E7907A-03

S E R V I C E N O T E

E7907A 2-Port OC-3c/12c ATM/POS Routing Test Card

**Sometimes E7907A fails to power up.
Applies to any units not modified to A10 indicated by the label on the main
PCA as shown in Figure 1 and Figure 2.**

Figure 1 - Identification

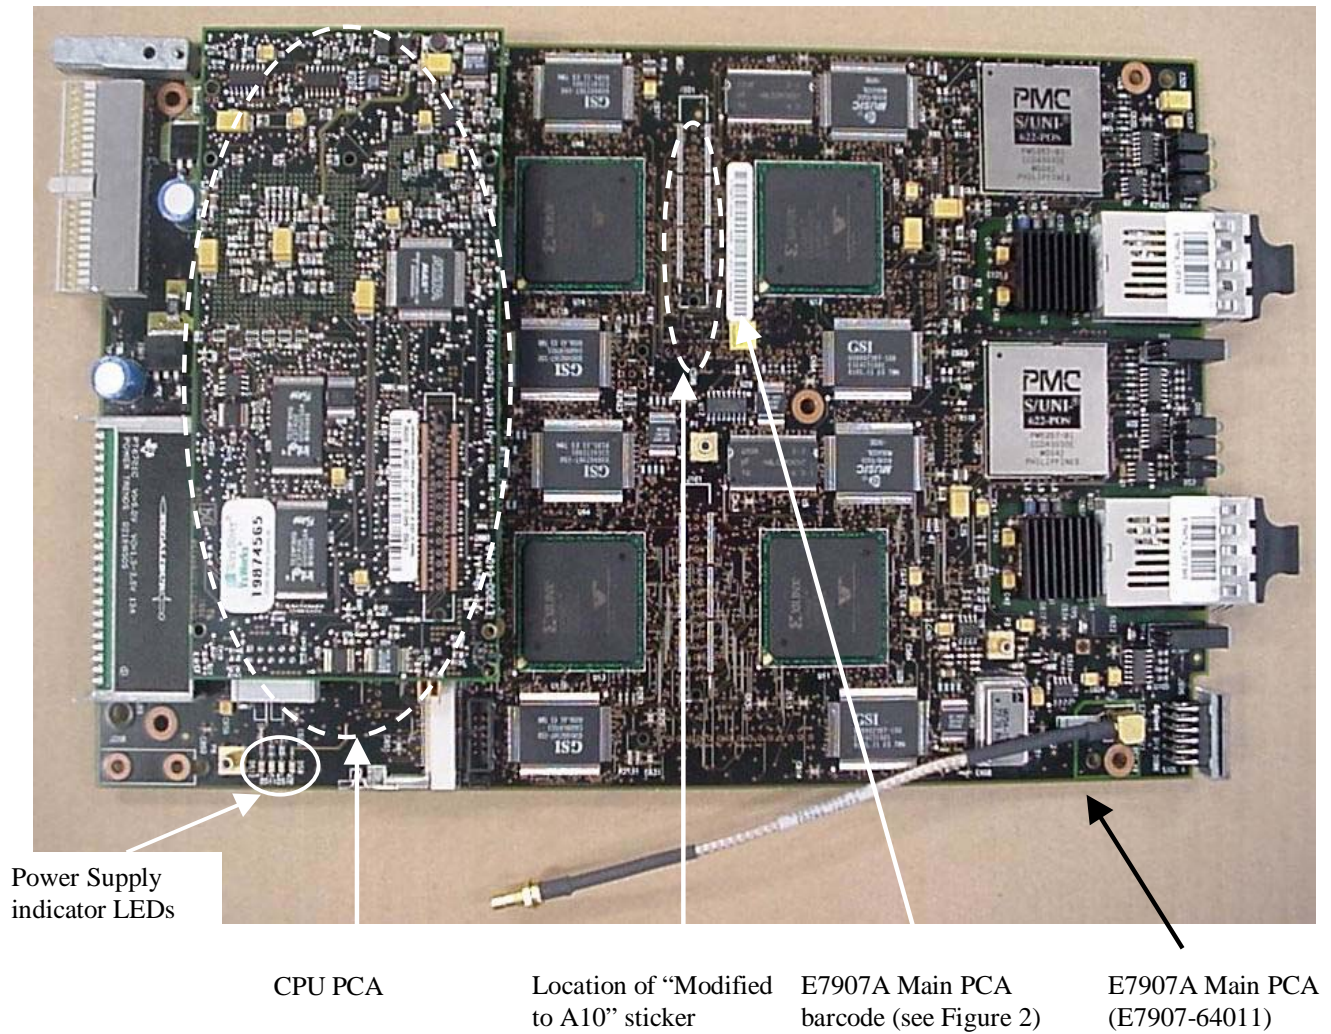
The failure of the E7907A Test Card to power up is detected by the absence of any LED activity on the front panel of the Test Card. Alternatively, in an open RouterTester 900 4-Slot Chassis (E7900A) the power supply LED indicators (located at the rear left of the E7907A Test Card) fail to light when the Chassis is powered up, refer to Figure 1 on page 3.

1. Remove the E7907A Test Card from the E7900A Chassis.
2. Determine the current revision of the E7907A main PCA as follows (see Figure 1 below):
 - If a sticker is found on the E7907A main PCA indicating “Modified to A10” or “Modified A10”, no further work is required. Do not confuse with a potentially similar sticker on the CPU PCA.
 - If the E7907A main PCA barcode sticker indicates A10, no further work is required. Refer to Figure 2 below where the barcode sticker indicates PCA revision A09. In the absence of a “Modified to A10” sticker, the modification will be required.
 - The E7907A main PCA barcode sticker is generally located near U12, however on earlier versions of the PCA this sticker was randomly positioned on either side of the PCA by the Contract Manufacturer.
 - Do Not confuse the barcode sticker on the CPU PCA with that of the main E7907A PCA sticker.

16. Check that the E7907A TestCard power rail indication LEDs are all lit. Refer to Figure 1 on page 3 for their location on the main PCA. If any of these LEDs fail to light, re check the capacitor solder joints.
17. Check that the E7907A TestCard has correctly numbered up (refer to the Built In Self Test section of the E7900A service manual for further information).
18. Execute the Automated diagnostics section of the E7900A service manual with the E7907A TestCard in slot number one of the E7900A chassis to verify that operation of the E7907A TestCard.
19. End of process.

Figure 2 - E7907A PCA identification Barcode

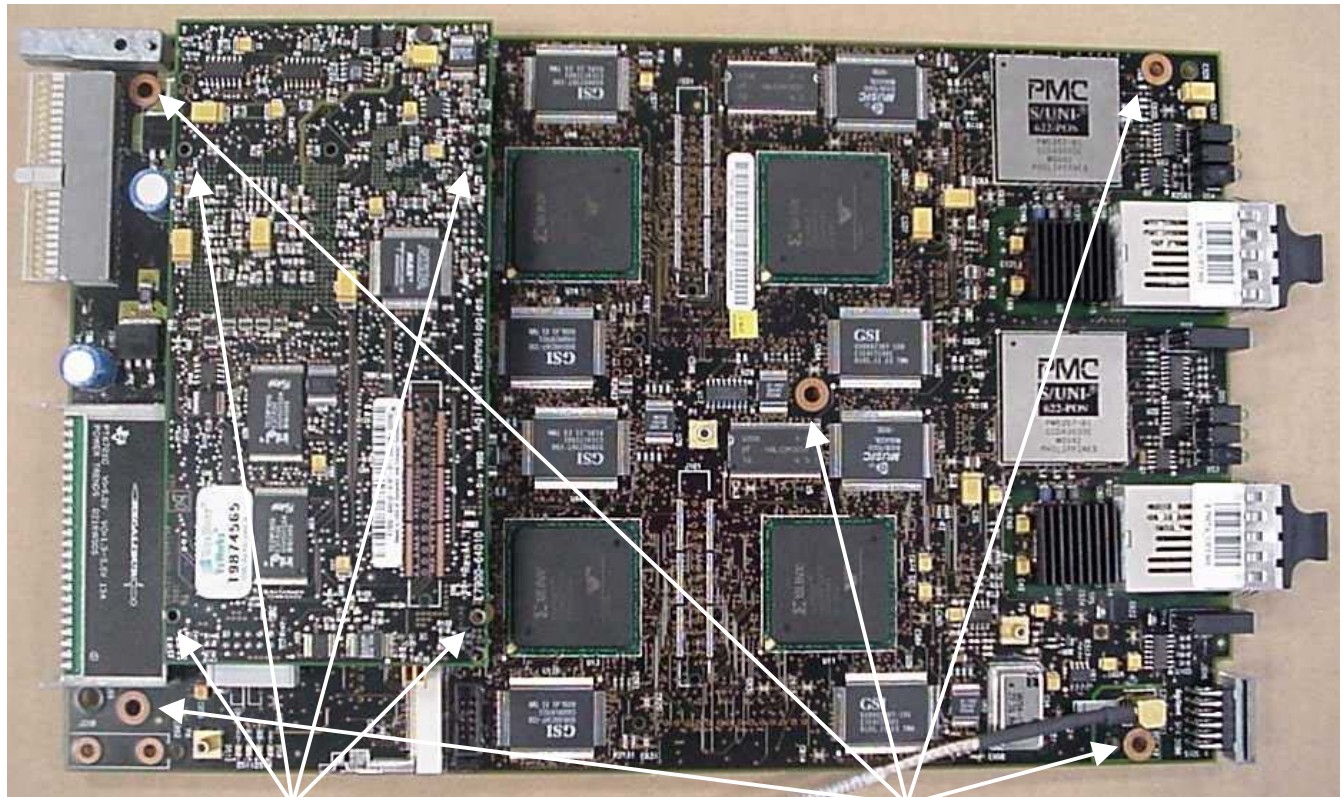
PCA Modification / Revision number

Figure 3 - Retaining Screw Positions

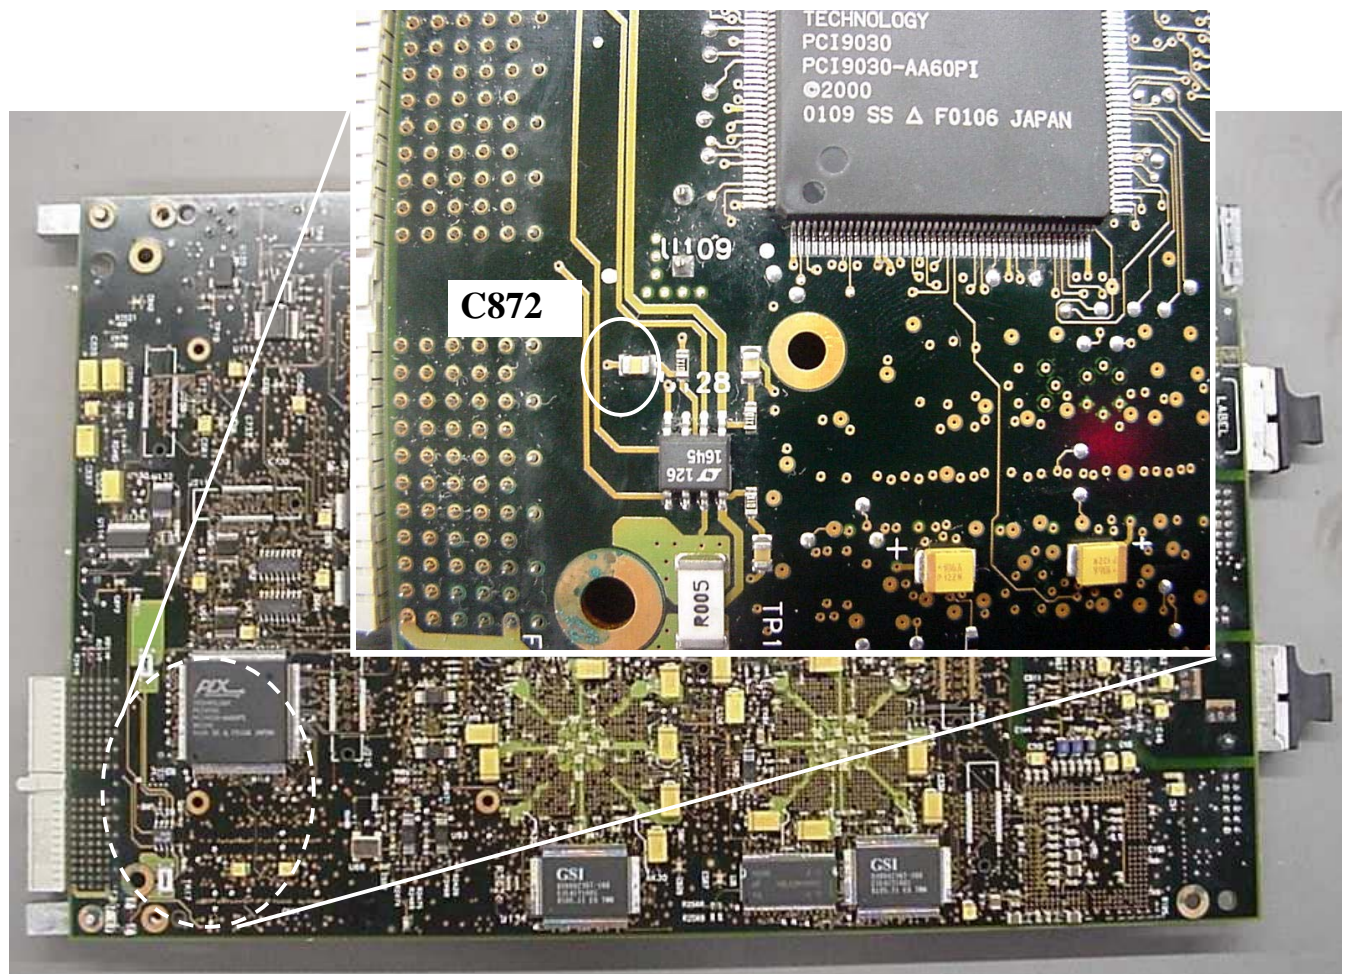
3. Remove the retaining nut of the SMB connector on the E7907A Test Card front panel and pull the cable clear.
4. Remove the four retaining screws of the CPU PCA and carefully remove the PCA from the main E7907A Test Card PCA, refer to Figure 3 below
5. Remove the six retaining screws of the main E7907A Test Card PCA, refer to Figure 3 below. Slightly raise the rear of the PCA so that the standoff's are clear of the underside of PCA to ensure that no surface mount components are knocked off the PCA and slowly pull the PCA optics modules clear of the front panel.

Note: The sixth E7907A Test Card PCA retaining screw, location not shown above, is positioned in the center of the PCA directly under the leading edge (closer to the front panel) of the CPU PCA.
